**REMARKS**

Claims 1-21 and 23 are currently pending in the application. Applicant has canceled claim 22, and amended claims 2, 6, 8, 10, 11, 18, and 21. Applicant requests reconsideration of the application in light of the following remarks.

FIG. 5

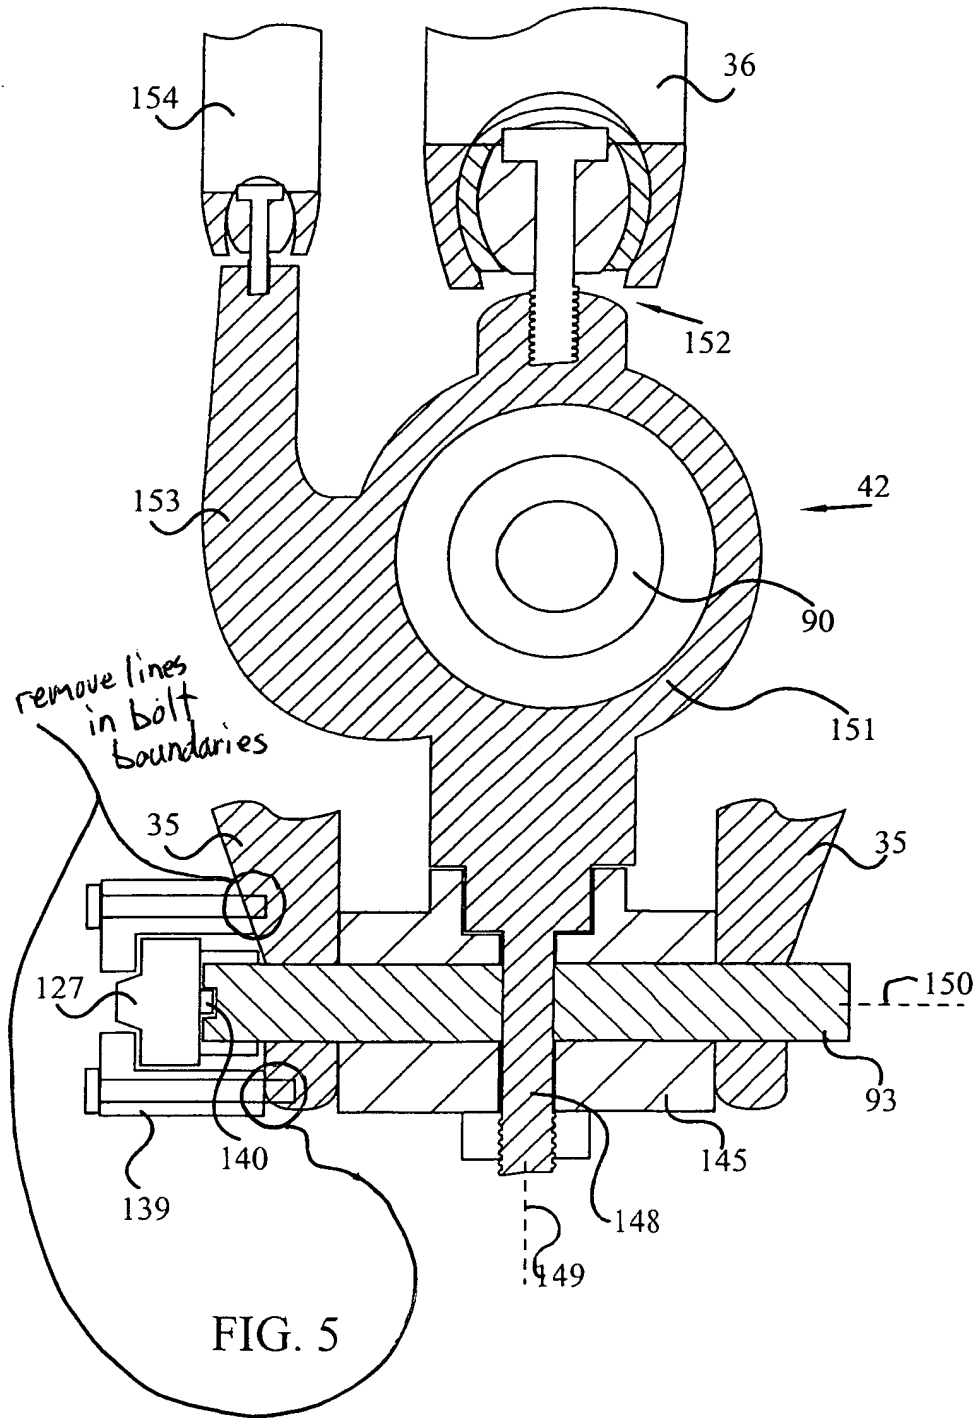
An additional change was made to Figure 5 to remove cross hatching and object lines within the boundaries of bolts at the lower left of the drawing Figure.

FIG. 8

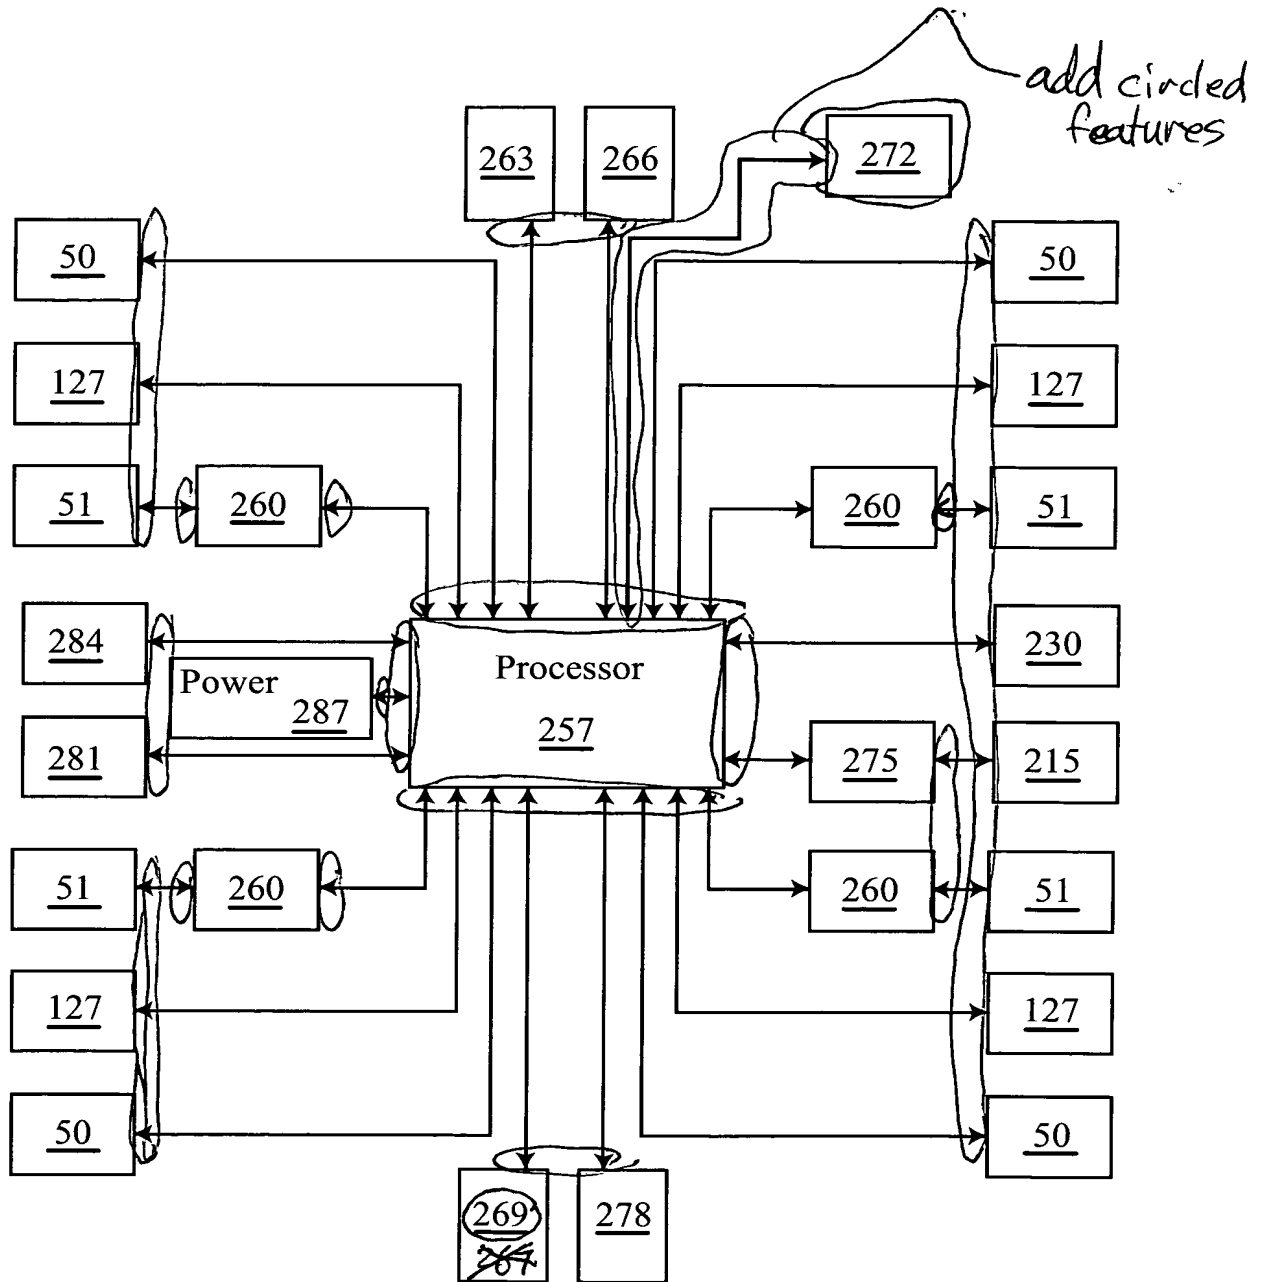
Regarding the objection to Figure 8, the figure has been modified to reflect that flow of signals may be in both directions. Support for this is found at page 23, lines 25-27 and page 24, lines 2-3 in which the ECU 257 receives feedback, sends out control signals, and provides responses based on input from the various electrical components.

Regarding nonexistence of reference numeral 269 in the figures, Figure 8 has been amended to include this reference numeral.

Regarding nonexistence of reference numeral 272 in the figures, Figure 8 has been amended to include this reference numeral.
